Item 01

Location: Land to the south of 188 St Anns Road, Prestwich, Manchester, M25 9QS

Proposal: Outline application for the erection of 1 no. four bed dwelling with associated landscaping, bins, bikes, and parking (access and landscaping matters reserved)

Application Ref: 72700/Outline Planning
Permission

Location & Block Plan

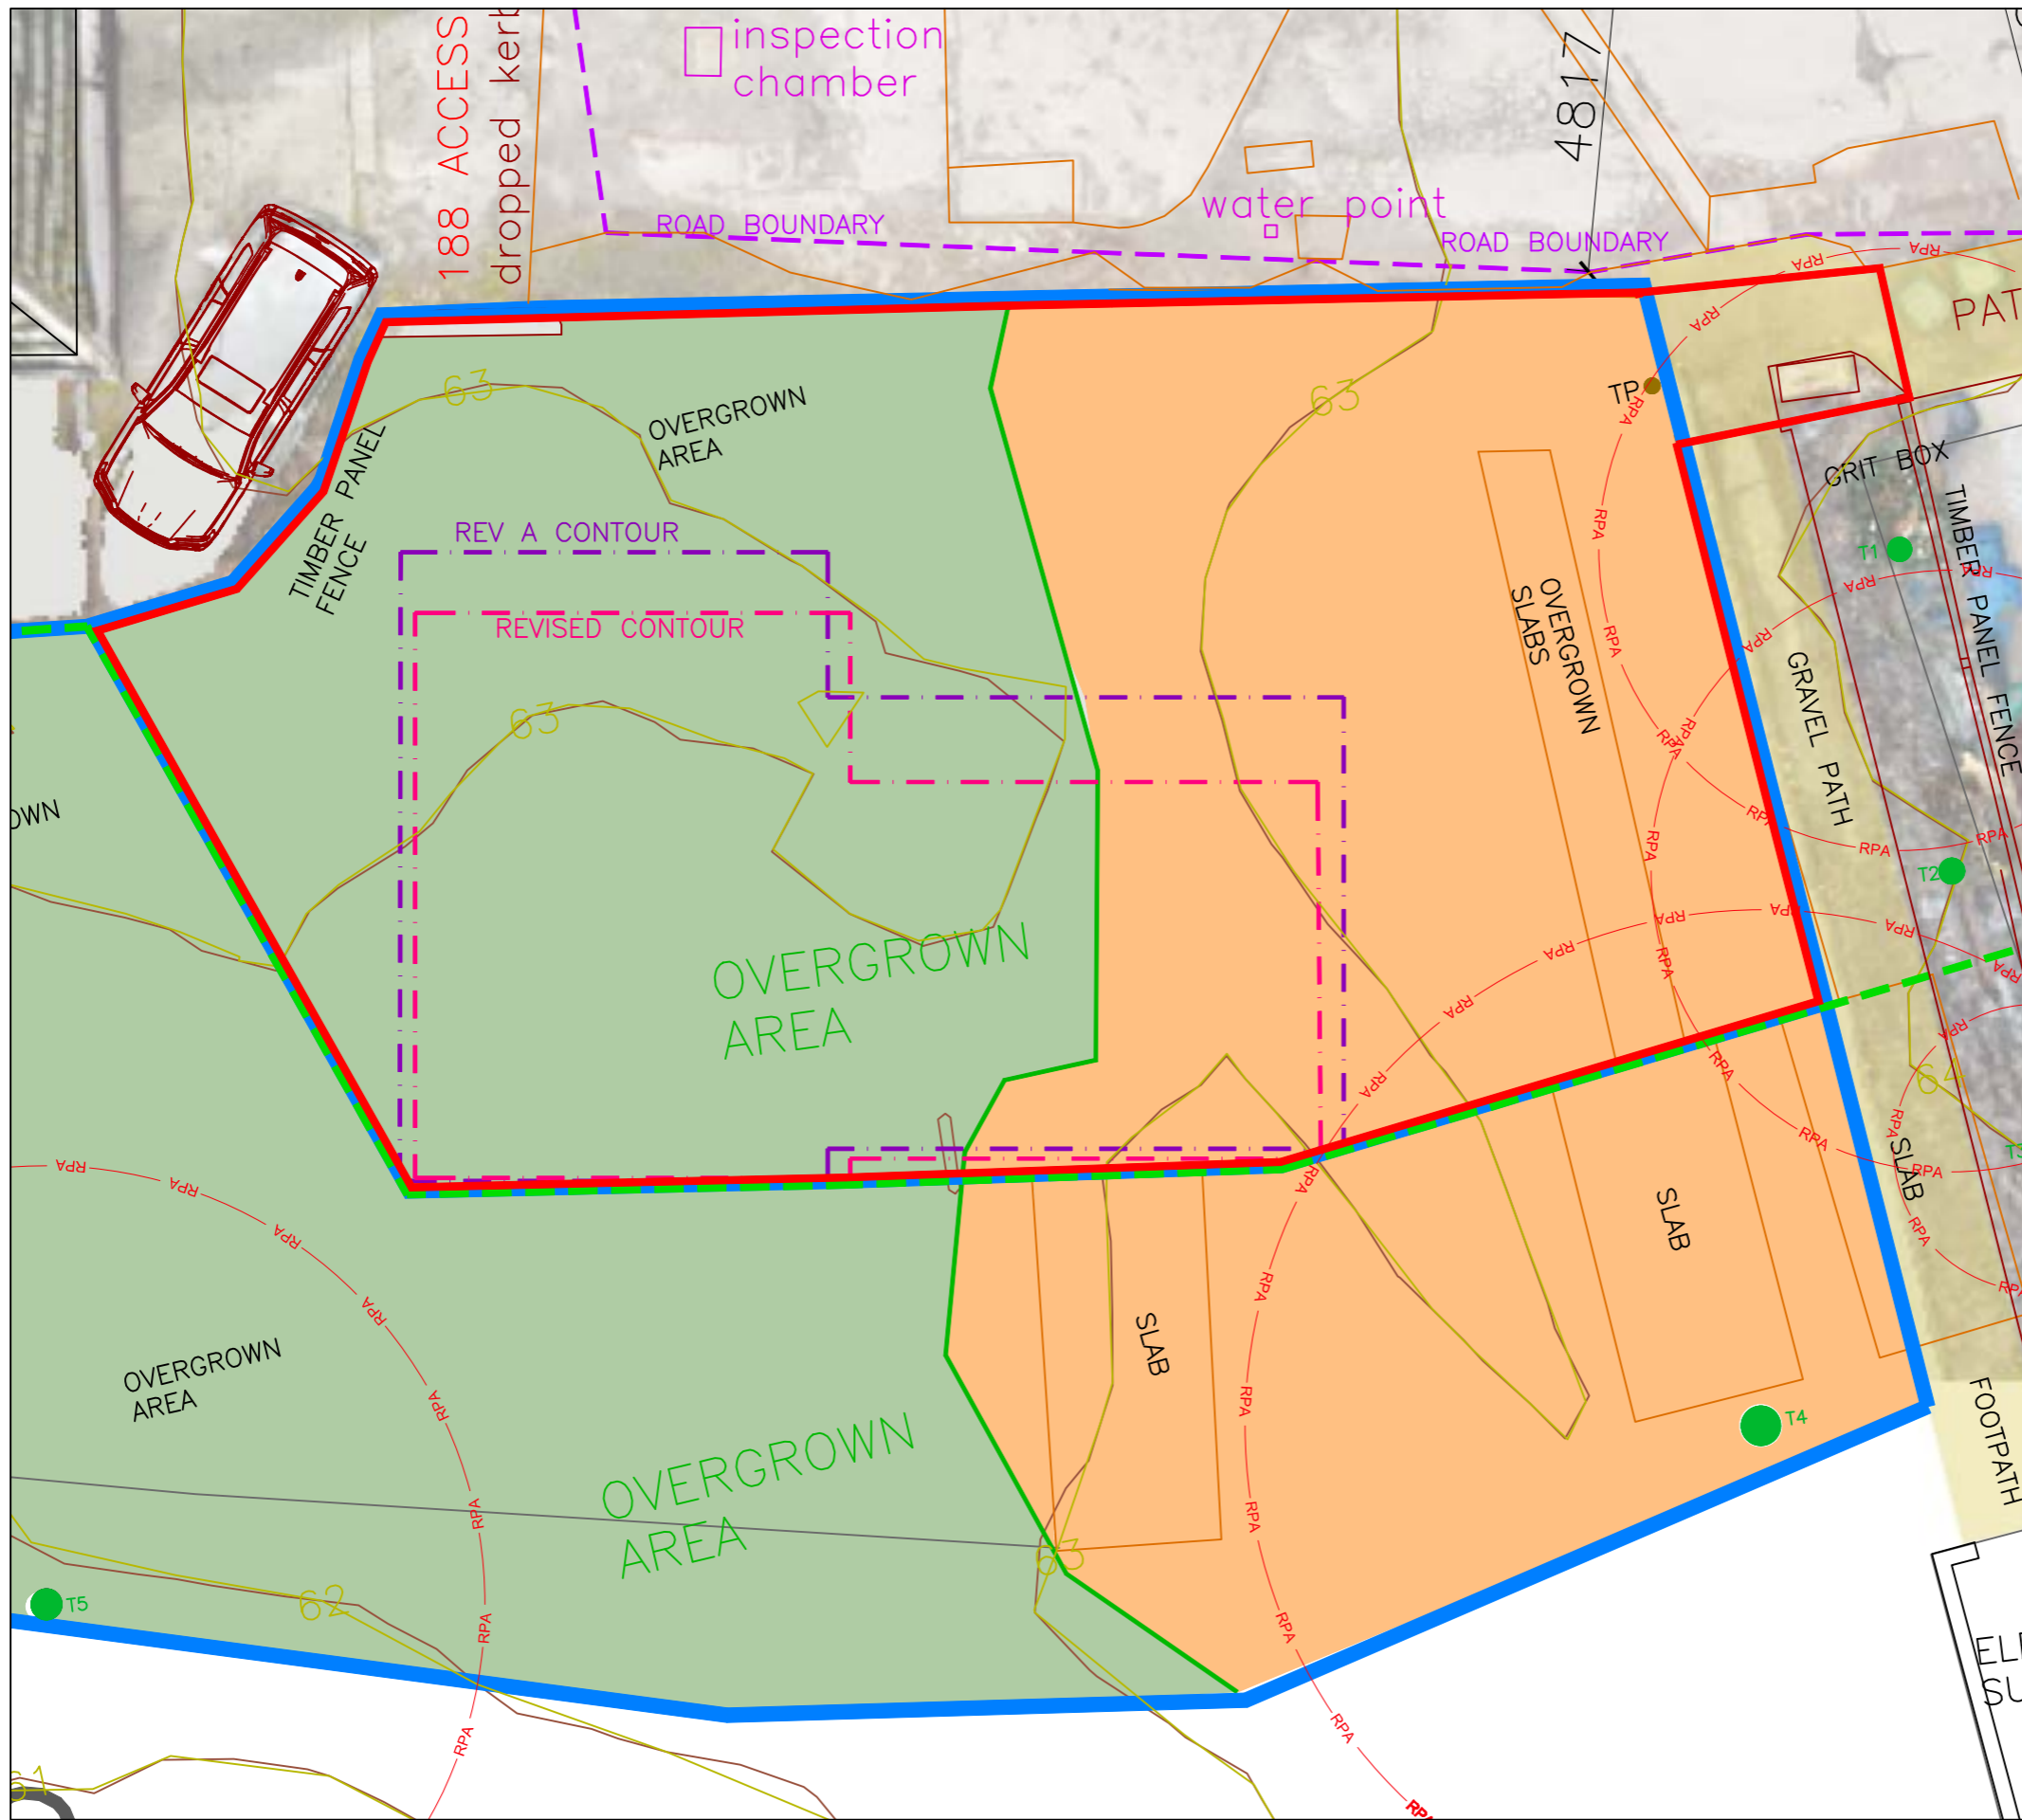
5. The area edged in blue on drawings 200 Rev D and 600 Rev D to the rear of the site shall not be used as garden or residential amenity space in association with the dwelling hereby approved.
- Reason. To prevent inappropriate development in the Green Belt and protected recreation space pursuant to policies of the Unitary Development Plan and Places for Everyone Joint Development Plan listed.
